LTR-NRC-22-7

Subject: Fuel Criterion Evaluation Process (FCEP) Notification of the 17x17 OFA PRIME Fuel Product Implementation (Proprietary/Non-Proprietary)

**Fuel Criterion Evaluation Process (FCEP) Notification of the 17x17 OFA  
PRIME Fuel Product Implementation**

**Figure 1: 17x17 OFA Mid Grid Assembly (Vertical Spring Design)**

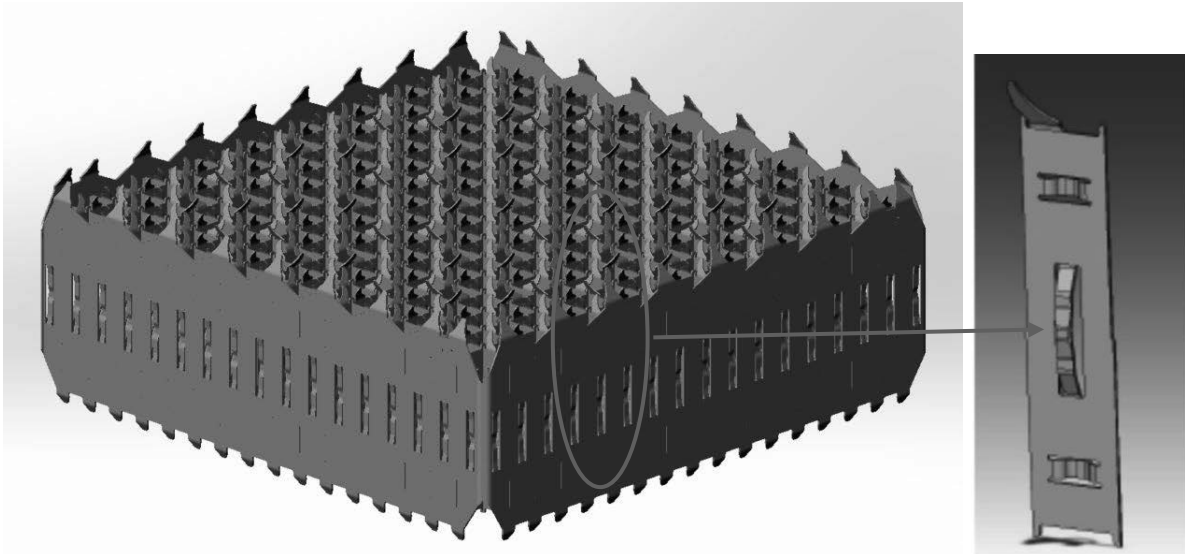
The new grids are essentially identical to the existing **ZIRLO** grids, except that the grid material is **LTZ**. This material change applies to grids with both “balanced” and “unbalanced” vane patterns. The **LTZ** material tends to reduce the corrosion rate, which can provide an incremental benefit for grid growth. For other grid properties, the **LTZ** grid functions in the same manner as traditional **ZIRLO** grids with respect

to the primary functions of the grid, such as, fuel rod support and flow mixing, etc. [ ]<sup>a,c</sup> This conclusion applies to both the **LTZ** mid grids and to the **LTZ** IFM grids. All applicable design and safety criteria remain satisfied.

**Figure 2: Standardized Debris Filter Bottom Nozzle (3D View)**

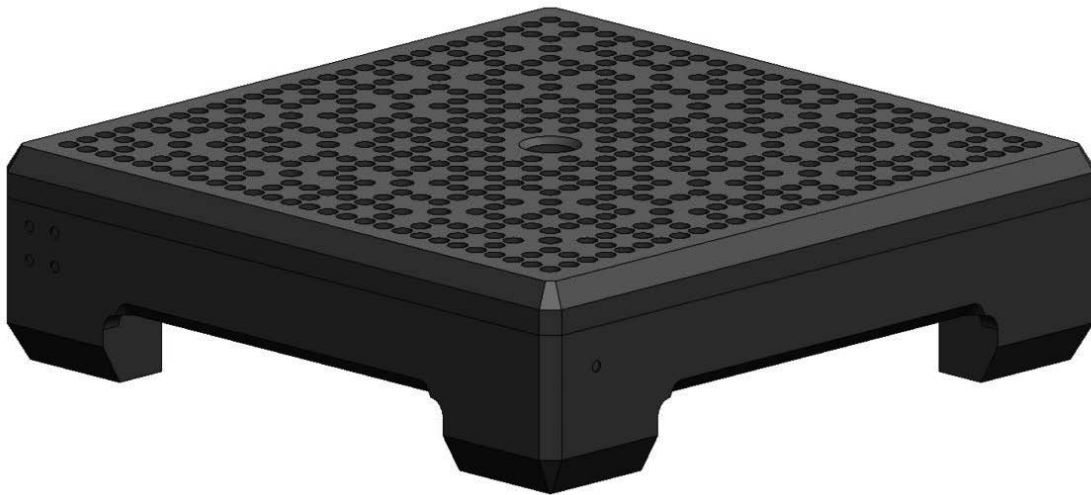
The 17 OFA **PRIME** fuel uses the **PRIME** Bottom Nozzle with low pressure drop flow holes and ADFBN side skirts. The 17x17 ADFBN design is currently being used successfully in operating plants. The **PRIME** Bottom Nozzle has a Next Generation Fuel (NGF) style [

] <sup>a,c</sup> as compared to the current SDFBN design shown above. In addition, a second key feature of the **PRIME** Bottom Nozzle design is that the side skirts are lowered for improved debris mitigation as they were for the ADFBN design (Reference 2). Each of these two features are discussed herein and have been previously incorporated into existing bottom nozzle designs, such as for the NGF bottom nozzle design which has [ <sup>a,c</sup> and the 17x17 ADFBN design which lowered the side skirts to improve debris mitigation.

As shown in Figure 2, the SDFBN skirt has an opening that is [ ]<sup>a.c</sup> This opening could provide a path for debris to migrate into the open channel/gap between fuel assemblies and into the fuel bundle region which could potentially cause debris-induced fretting leakers on the peripheral fuel rods of the fuel assembly.

As a result of this limitation in the design of the 17x17 SDFBN bottom nozzle, the **PRIME** Bottom Nozzle design lowers the side skirts so that they are only [ ]<sup>a.c</sup> For the **PRIME** design, as shown in Figure 4 and Figure 5, [ ]
